## **Development Review Comments**

February 6, 2024 MAP2024-00120 PJT2024-00019 1st Submission Review Comments 5906 Halpine Road

**PRELIMINARY FOREST CONSERVATION** PLAN COVER

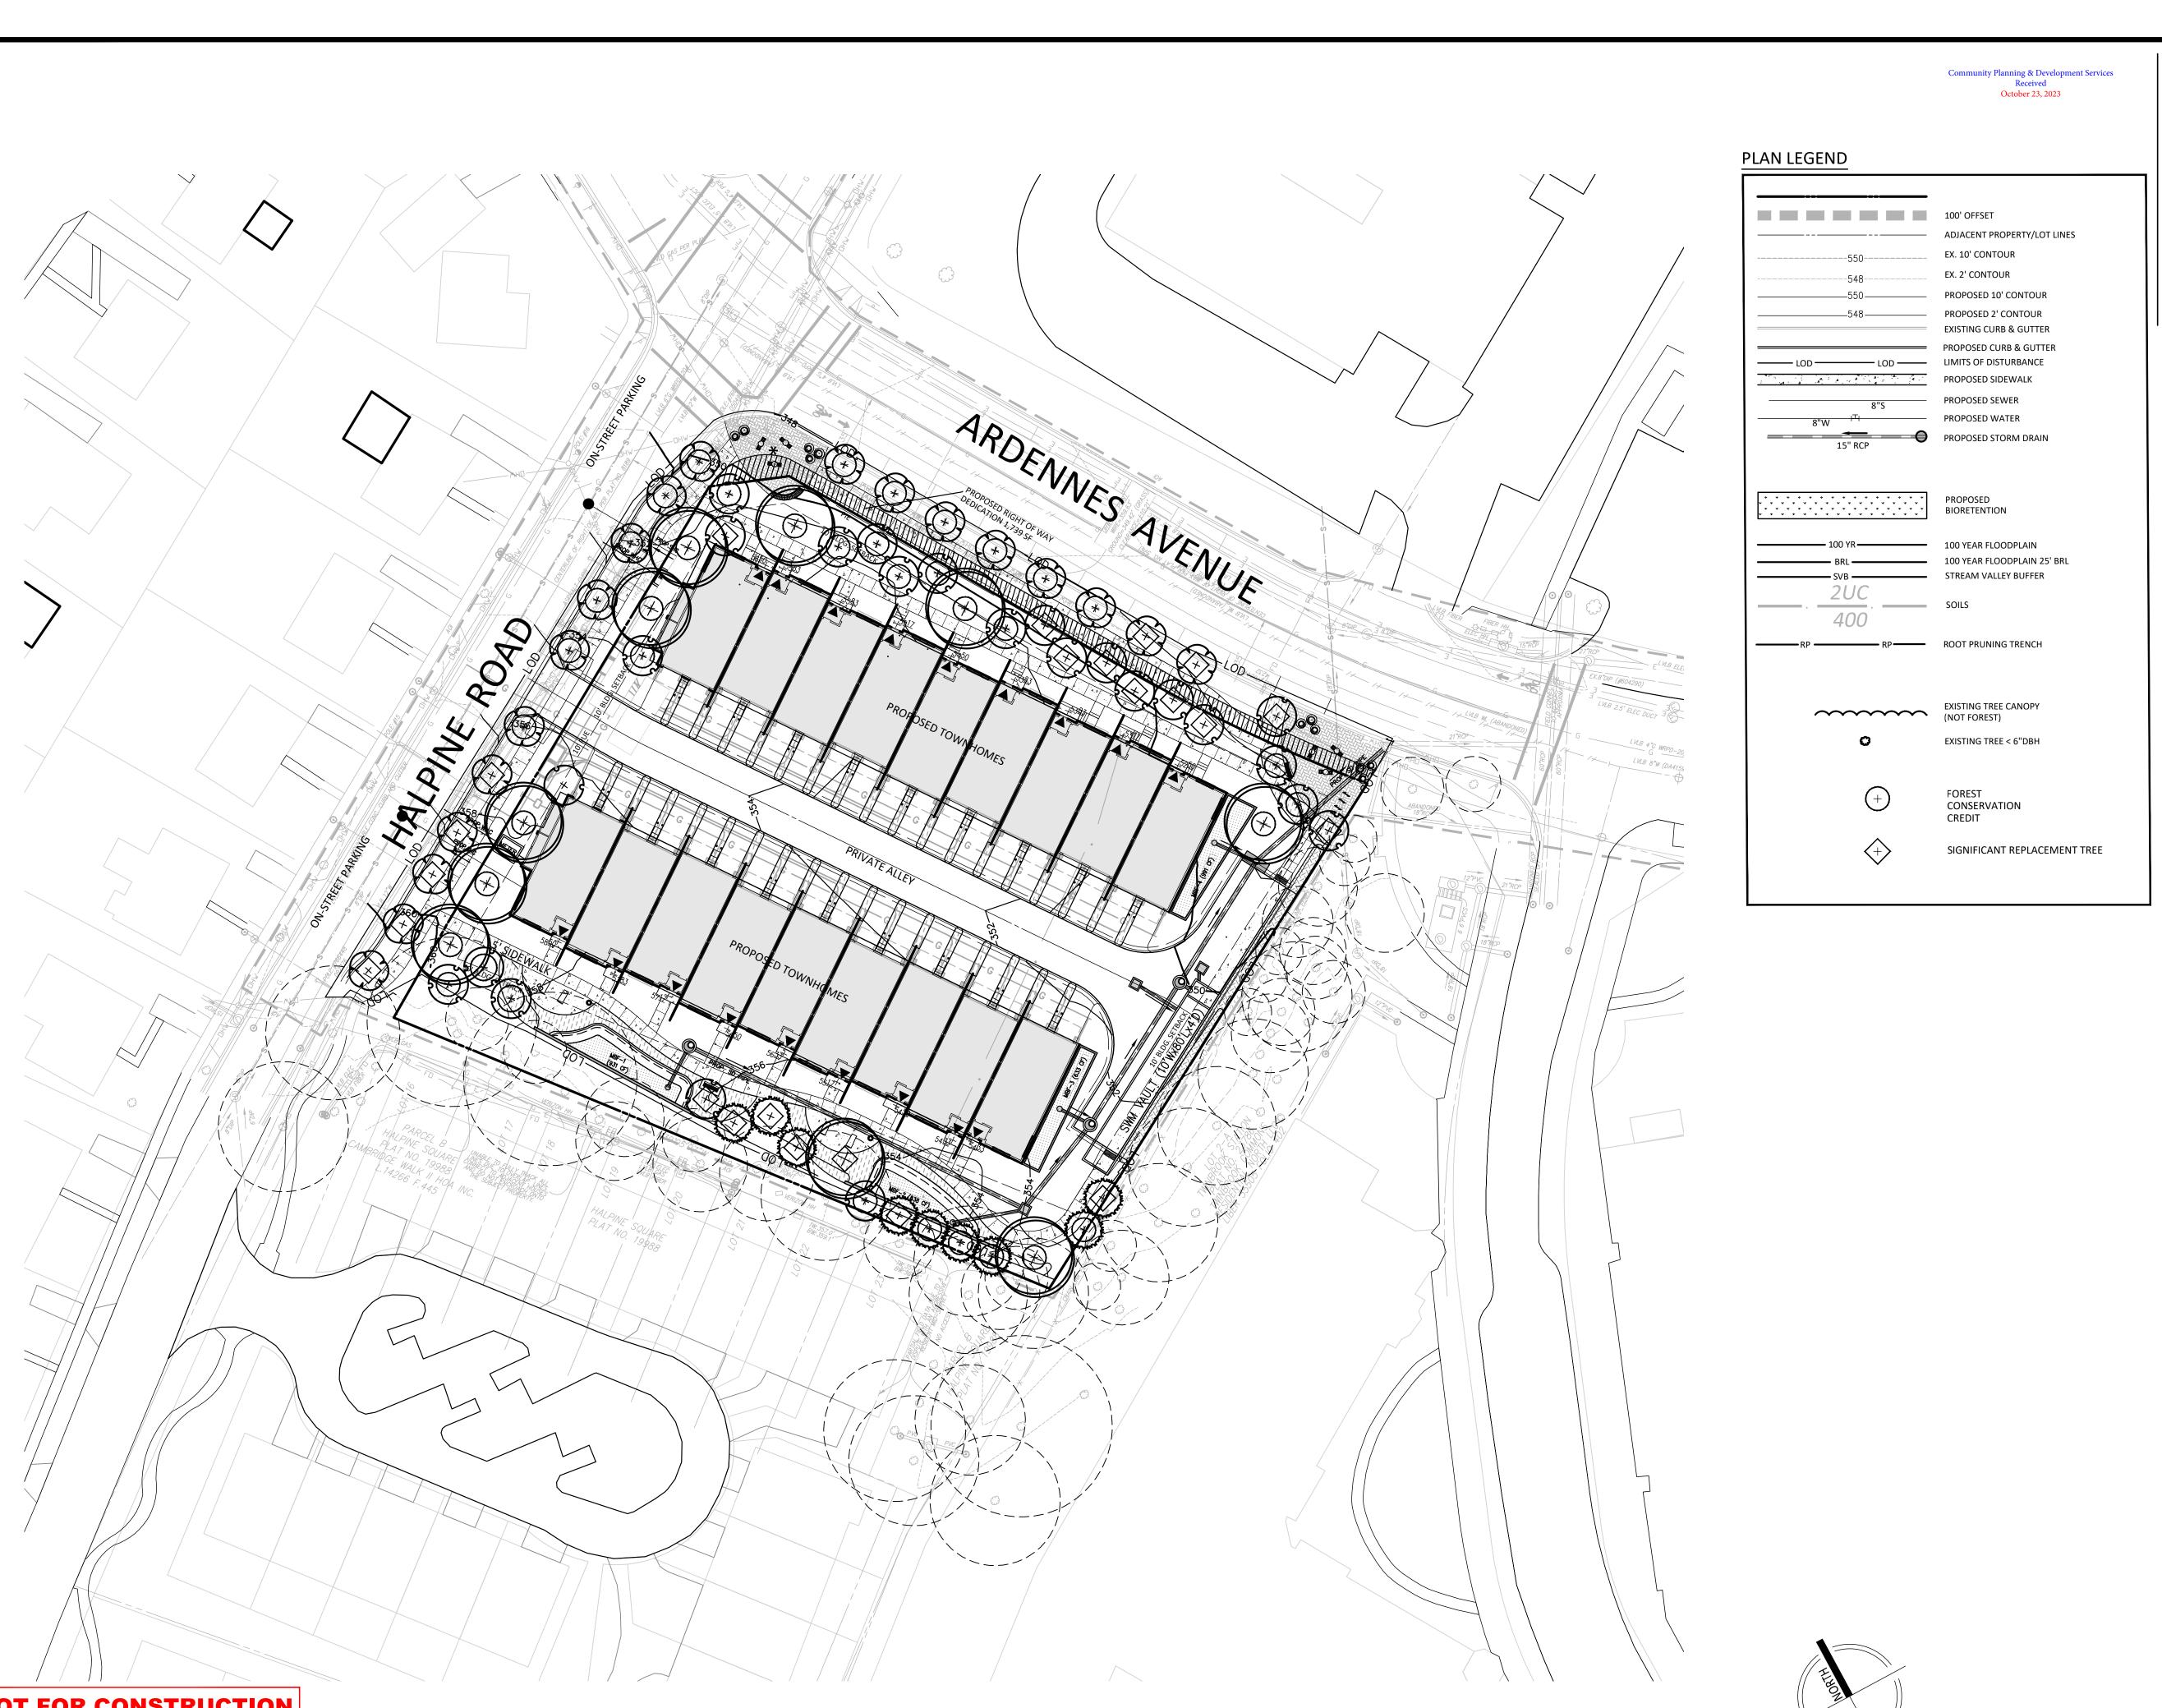
Further forestry comments will be given in Preliminary Forest Conservation Plan, received by CPDS on January 9, 2024 and currently under review. Comments may impact the overall design of the site that would affect the Project Plan and/or Site Plan.
